Bicycle Advisory Committee of the City of Los Angeles

Date: 6-3-15
Submitted in PWGR Committee
Council File No.: 05-0173
Item No.: 6
Deputy: public

Re: Council File 05-0173: Glendale/Hyperion Bridge Complex

RECOMMENDED OPTION

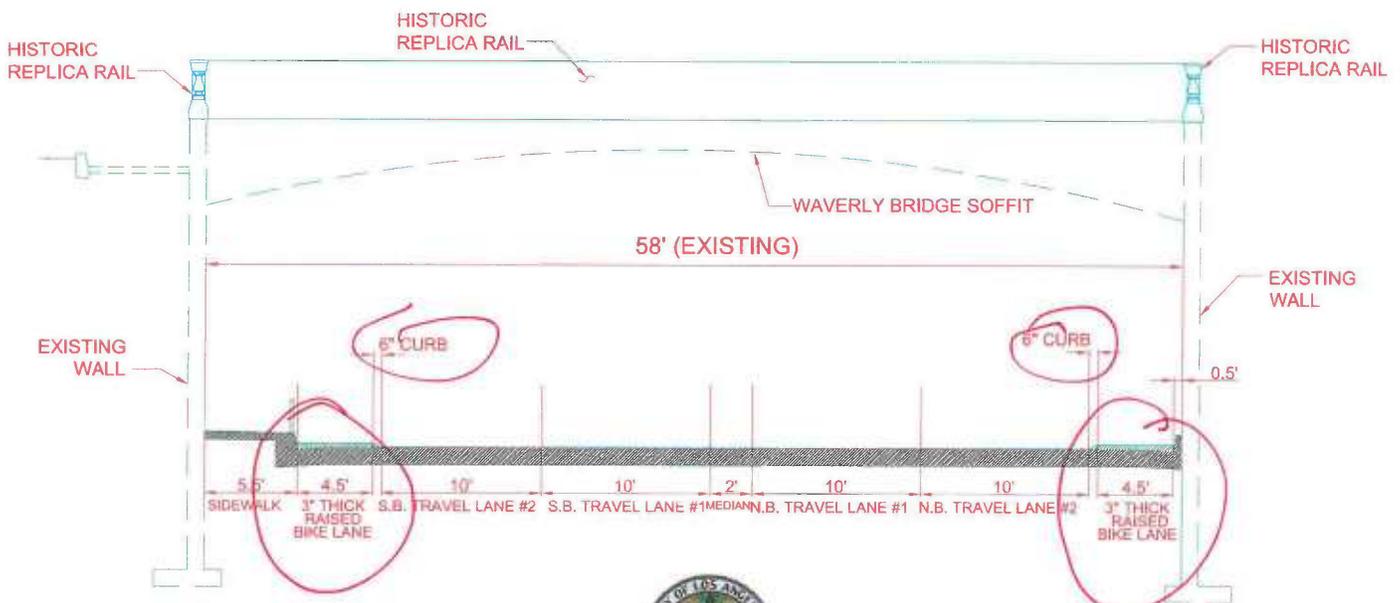
In some places, the documents state that the proposal includes “raised bike lanes”—which are a Class IV bikeway. Raised bike lanes are shown in Exhibit 8-1. Page 8-1 states “The bike lanes would consist of a 3-inch-thick raised surface.” Page 4 of Psomas’ May 28, 2015 memorandum states that the Project includes “Raised bike lanes on both sides of Hyperion Avenue.”

- b. The Recommended Option does not meet these standards; **at no point is it wider than 6 feet, and 4.5 feet under the Waverly Bridge**, where the east bikeway is immediately

- c. "When configured next to a motor vehicle travel lane, the desired minimum width of a mountable curb is 1 foot."
- d. The Recommended Option shows a 6" mountable curb width. The width and safety of the mountable curb—which allows people on bikes to safely move out of the bike lane to avoid people on foot or to pass slower people on bikes—is particularly important here where the cycle track is quite narrow. See also TDH p. 9-122 ("Mountable curb should have a 4:1 or flatter slope and have no lip that could catch bicycle tires.").

Bike lanes must be wider where there are gutter pans. Because bike tires are narrow, the size and position of drains, pavement seams, etc. are important concerns in the design of bikeways. Psomas' June 5, 2014 Technical Memorandum No. 6 states that, under various design standards, there must be "at least 3 feet of rideable width outside the gutter pan." According to Psomas, failure to provide this width "**could pose a safety concern.**" Nothing in the MND provides a level of detail sufficient to assess this "gutter pan" issue. A careful examination of the drawing suggests that BOE has simply erased gutter pans from the drawing of its proposed design, but not addresses this safety concern.

On June 2, 2015, the BAC voted unanimously to oppose the Bureau of Engineering's recommended design option for the Hyperion Bridge. Instead, we support a design along the basic outlines of Option 3, with three vehicle travel lanes, sidewalks on both sides of the bridge, and Class IV bikeways on both sides of the bridge that (1) meet City- and State-approved design guidelines; (2) are safe and comfortable for people of all ages and abilities who ride bicycles; and (3) are designed to meet future demand for bicycling, including access to the LA River Bike Path from both sides of the river.

Figure 4 Comparison of Existing and Proposed Pedestrian Facilities

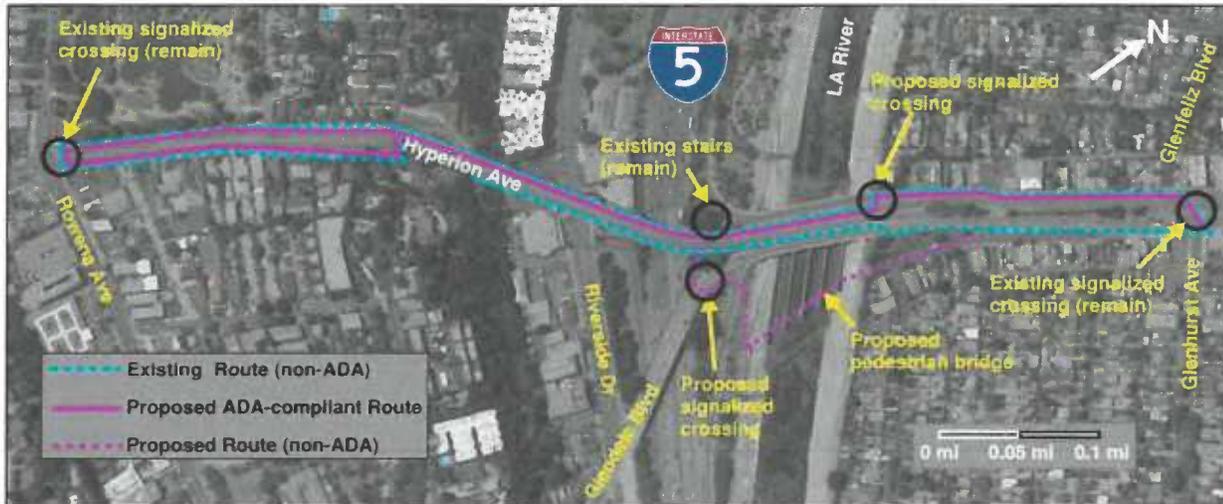
Based on Figure 4, as well as on information previously presented on this memorandum, the following are summaries of advantages and disadvantages of the recommended improvements when compared to the existing conditions.

1. Improved conditions for disabled pedestrians by adding an ADA-compliant Pedestrian Access Route (PAR) from one end of the project to the other. Eliminating the extremely narrow sidewalk (2-ft wide) near Waverly Drive will also help improve safety in the vicinity of the underpass.
2. Improve safety for pedestrians crossing southbound Glendale Blvd at the east end of the Hyperion bridge by installing a signalized crossing.
3. Provides an additional pedestrian facility with the new Red Car bridge over the LA River. The recommended signalized crosswalks at the Glendale Blvd/I-5 NB Off-ramp will minimize vehicle-pedestrian conflicts for people walking to and from the new Red Car bridge or Glendale Blvd.
4. Enhances bicyclist safety and encourages bicycling by adding raised bike lanes on both sides of Hyperion Avenue.

1. Eliminates the proposed sidewalk on the east side of the Hyperion bridge. This will require longer travel paths for pedestrians starting or ending their trips on the east side of Glendale Blvd between the LA River and Glenhurst Avenue. For able-bodied pedestrians who can negotiate

the stairs on the Hyperion bridge and use the Red Car pedestrian bridge, the increase in travel distance will be up to approximately 310 ft (1.5 min at 3.5 ft/s walking speed). Disabled pedestrians would have to travel to the Glenfeliz/Glenhurst intersection and back track on the other side of the road, adding up to approximately 1,550 ft in travel distance (7.4 min at 3.5 ft/s). The alternative routes described here are illustrated in the Appendix. However, it should be noted that there is no existing ADA-compliant route along Hyperion Avenue from Silver Lake to Atwater Village (the alternative route from Rowena to Glendale Blvd is longer than the PAR from the recommended option).
